**CITY OF AUSTIN
Board of Adjustment
Decision Sheet**

CASE NUMBER: C15-2017-0047

ADDRESS: 3602 & 3604 RIVERCREST DR

Wetlands Biologist Review - Liz Johnston - 512-974-2619

SITE PLAN, DOCK PLAN & ELEVATIONS

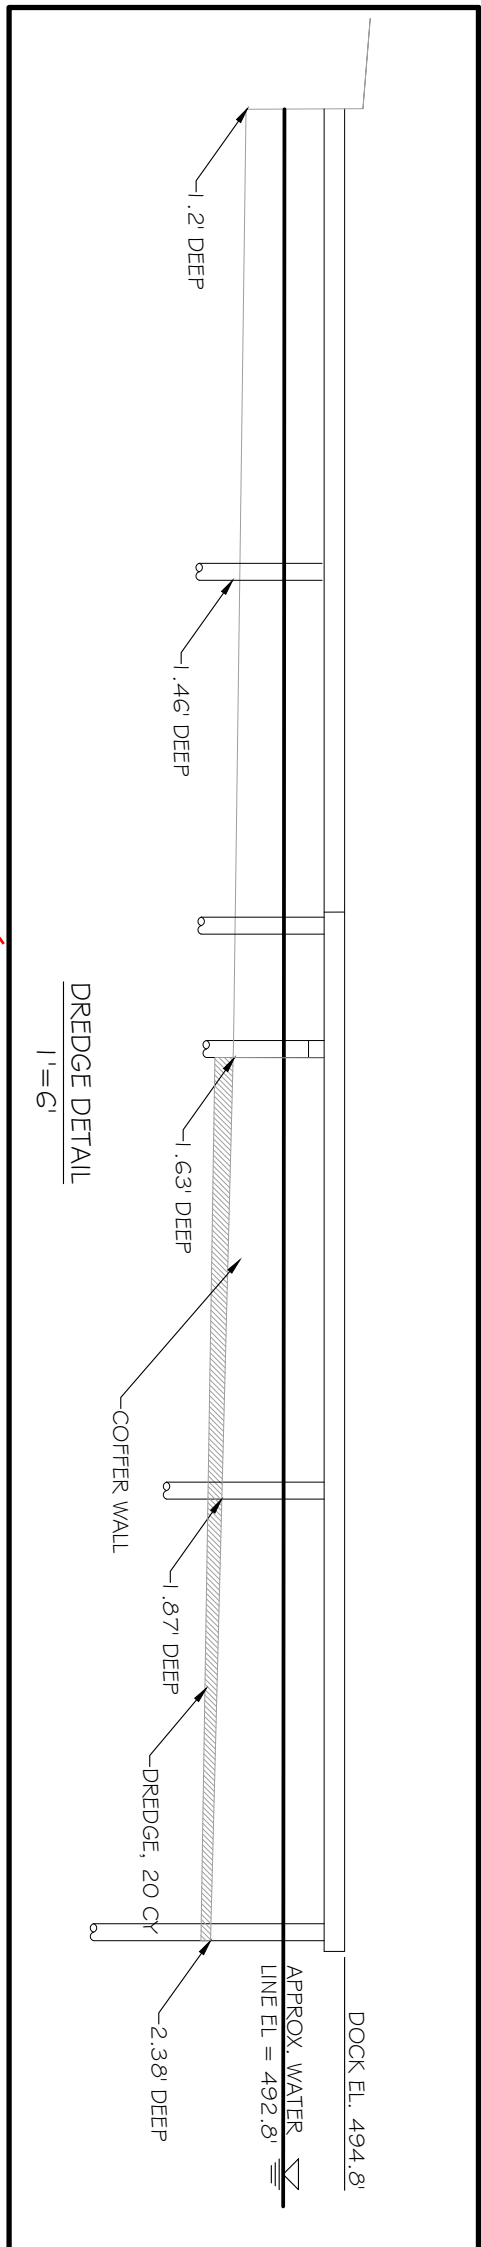
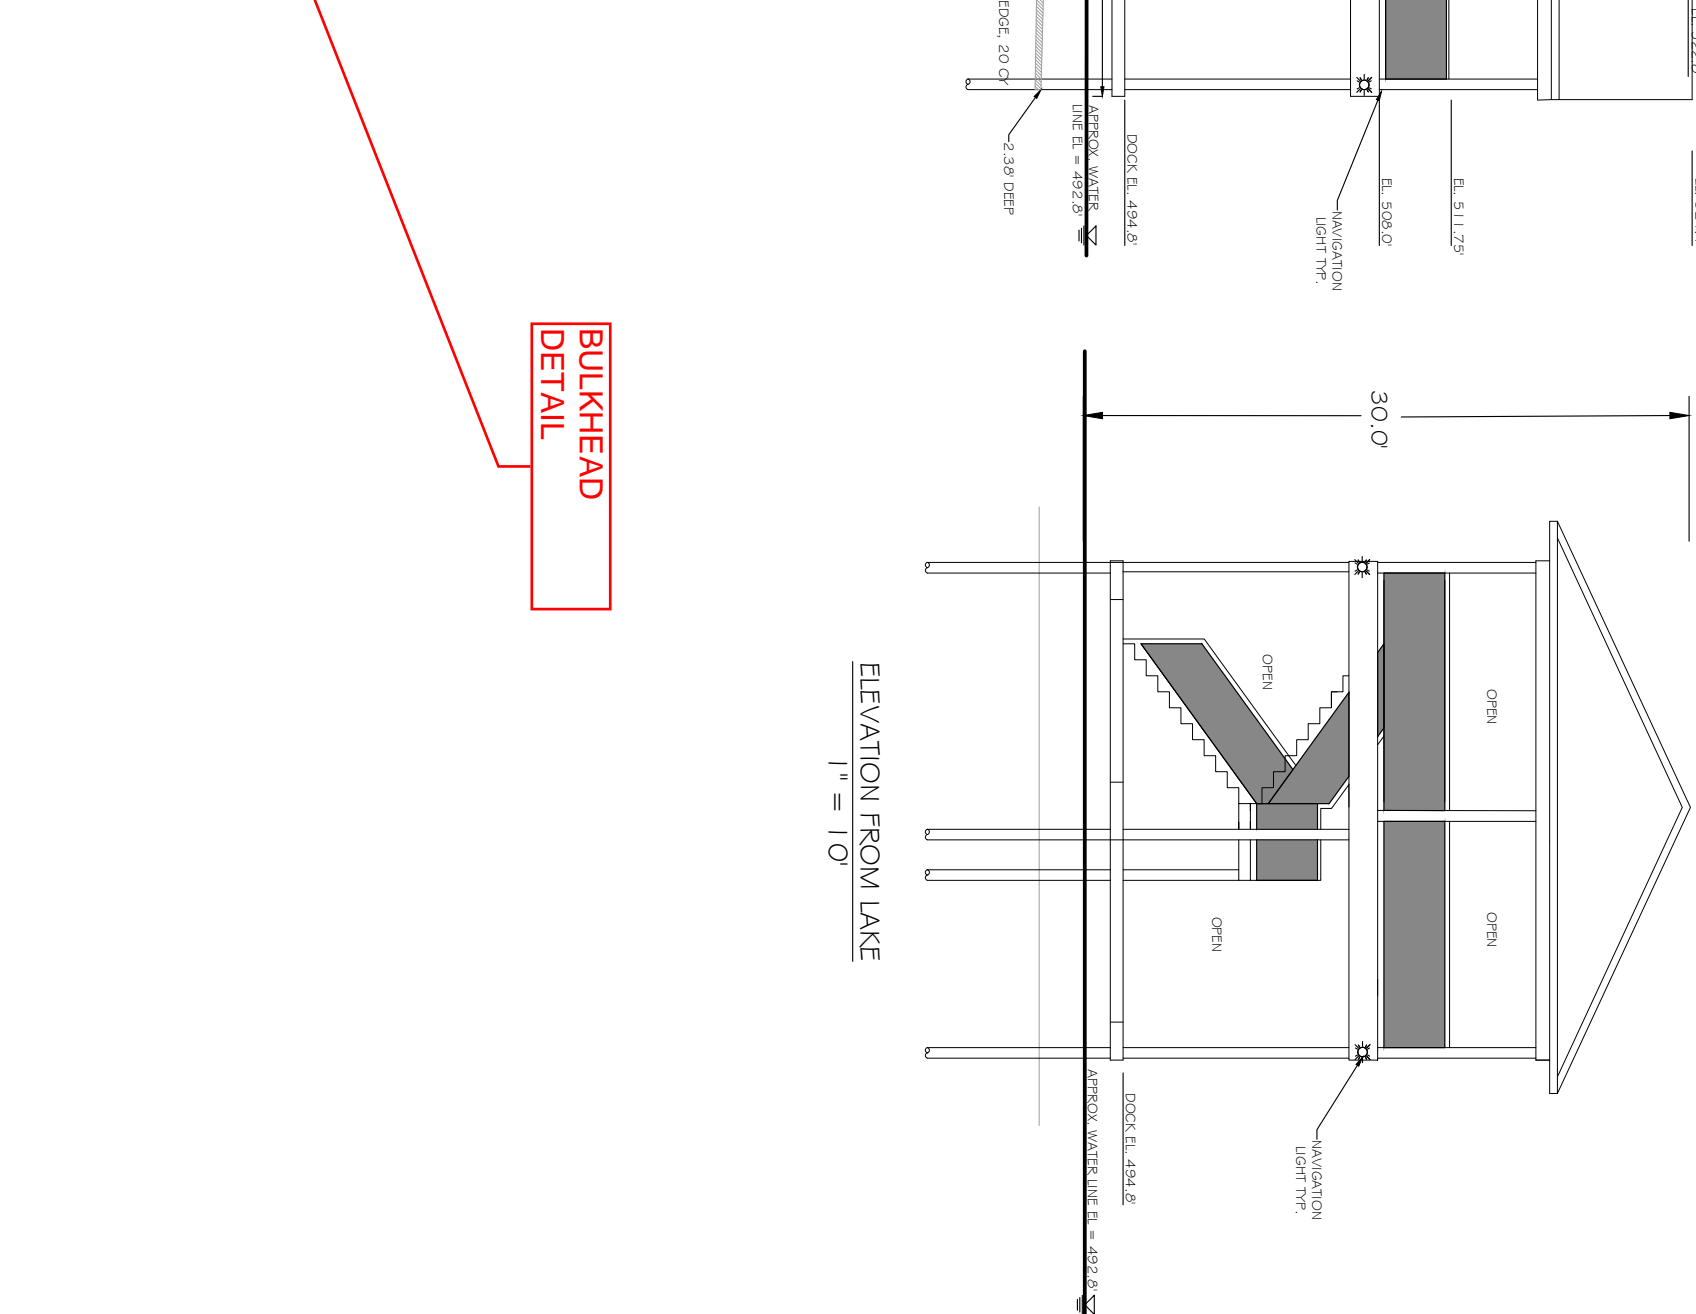
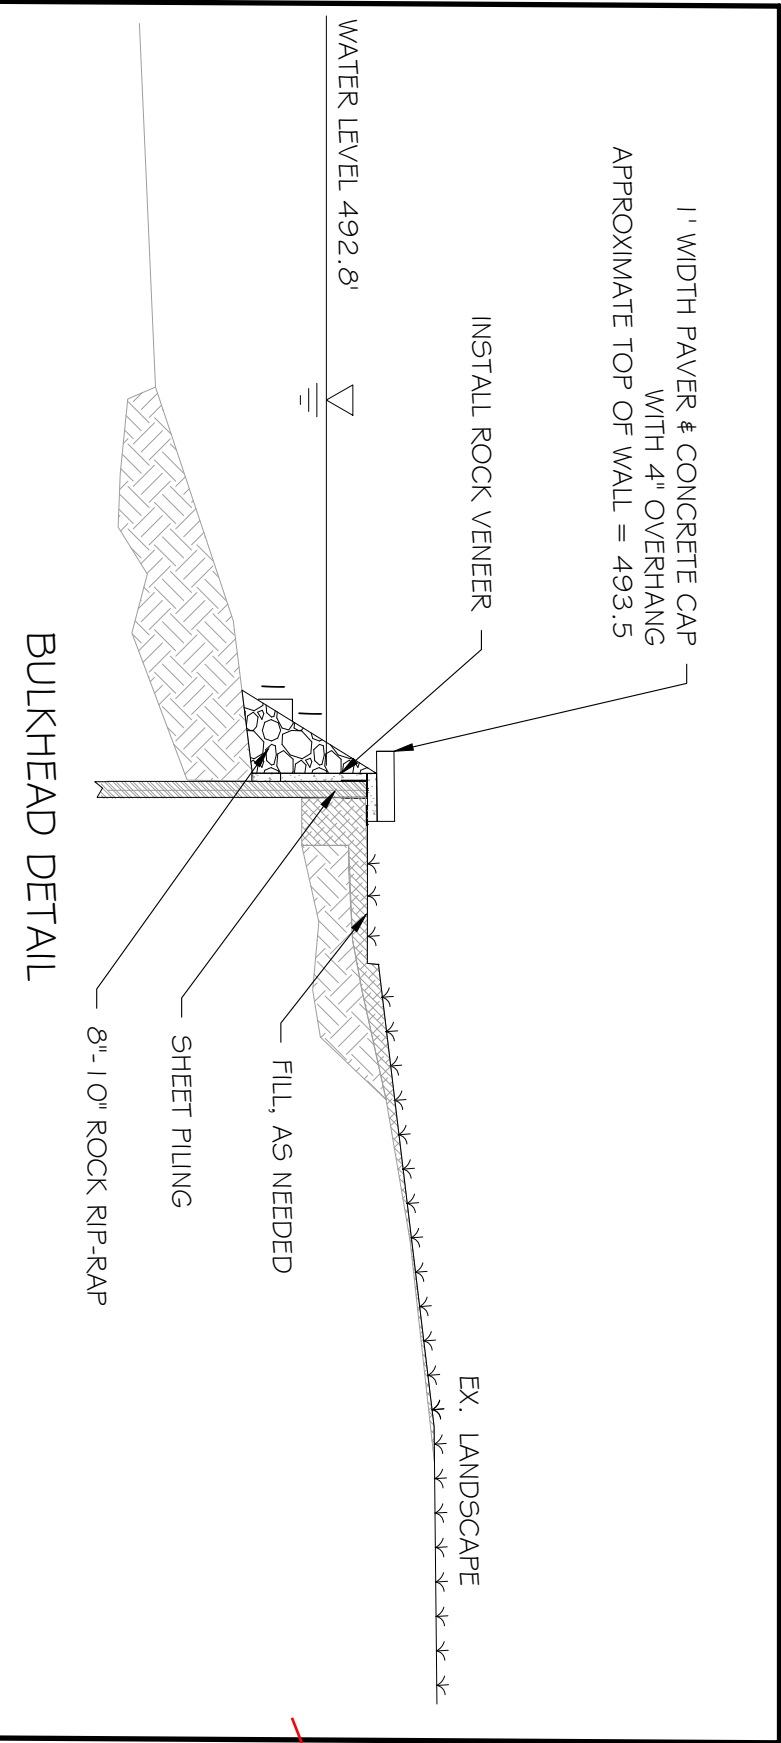
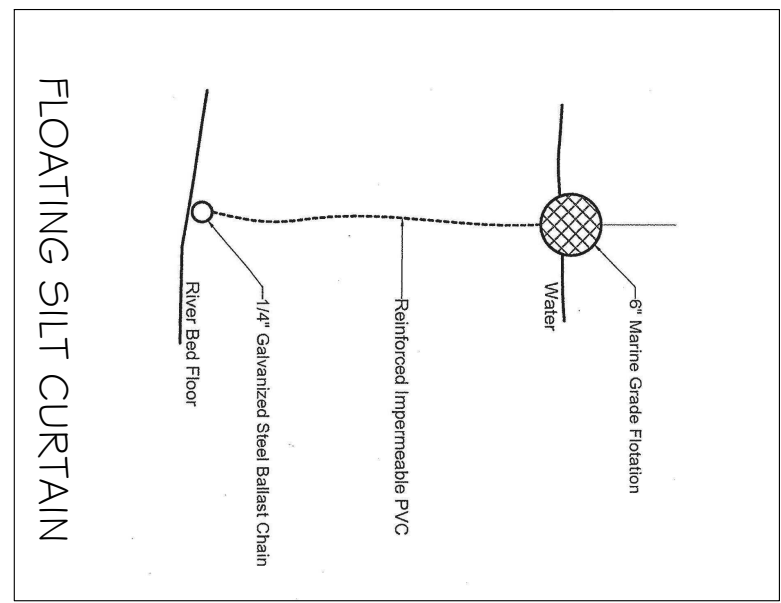
WB 3 Update 0 Provide accurate bathymetric profile information demonstrating how the 20 cubic yard dredging estimate was calculated.

Update 1: Show the dredging profile on the architectural elevation. **SEE SHEET 2**

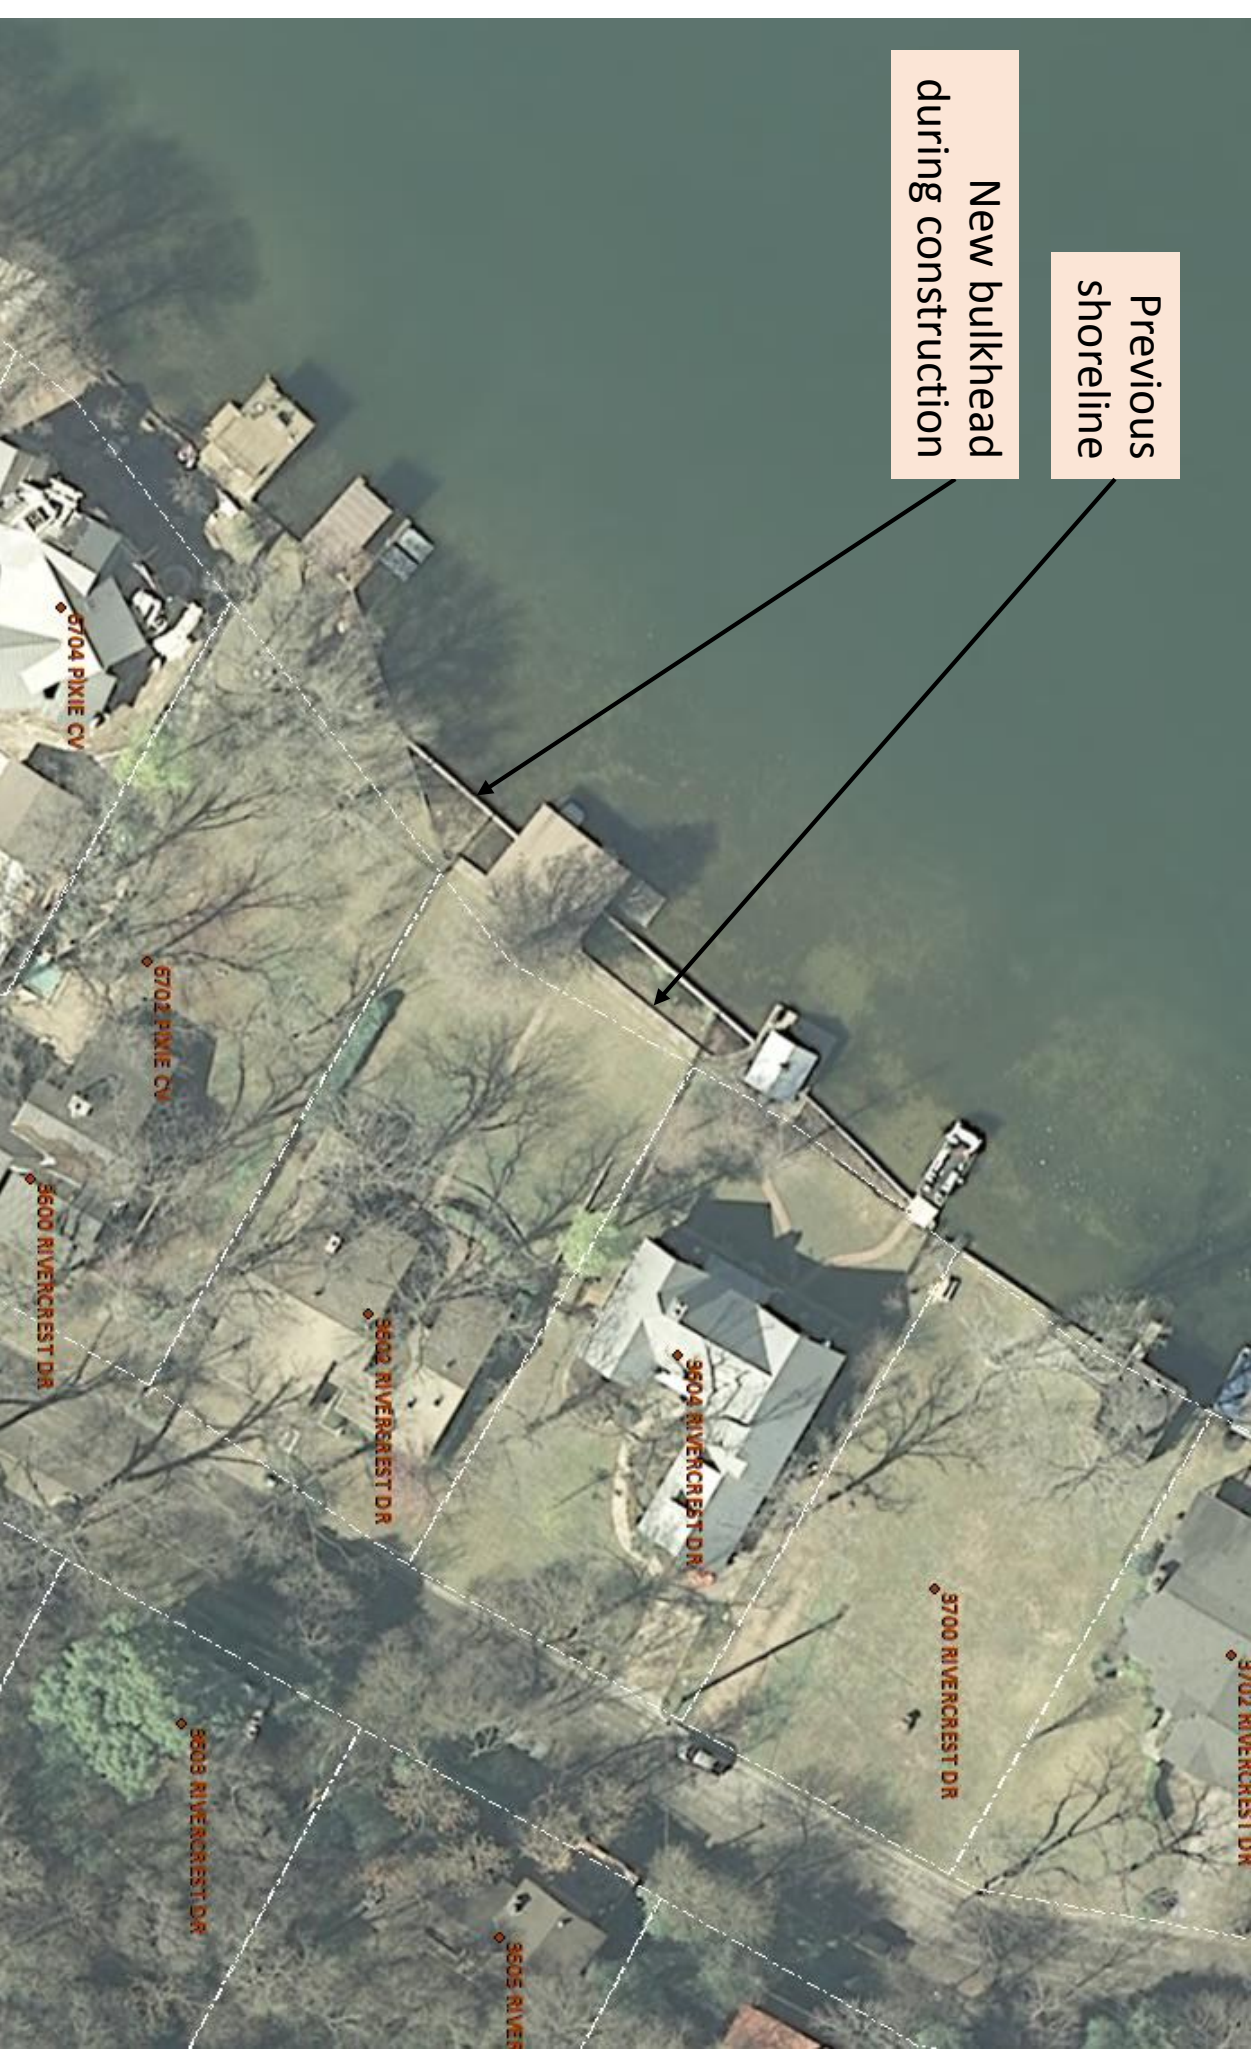
This memo is intended to provide relevant information related to a case before the Board requesting a variance to extend a dock greater than 30' into Lake Austin. Three adjoining properties along Rivercrest Dr, including 3602 and 3604 Rivercrest, are under an environmental code violation related to unpermitted land capture that occurred in 2009 when a new bulkhead was constructed up to approximately 15' from the previous shoreline. Previously inundated waters were backfilled and converted to yard area. When the work occurred, a site plan for a new bulkhead would have been required with approval of the Parks Board for the shoreline modification and environmental variances for construction not allowed within a Critical Water Quality Zone. However, no permits were secured for the work. See enclosed aerial imagery for reference.

The applicants have submitted a site plan application to construct a new dock at 3602 Rivercrest to replace their old dock and to permit the illegal fill area on both 3602 and 3604 Rivercrest. The applicant has requested that the Board allow them to extend the new dock 60' from the current shoreline, or approximately 74' from the previous shoreline's location, due to shallow water. Considering the environmental impacts associated with the land capture and the potential navigation hazard that would be associated with a dock extending so far into the lake, WPD is not in support of the request.
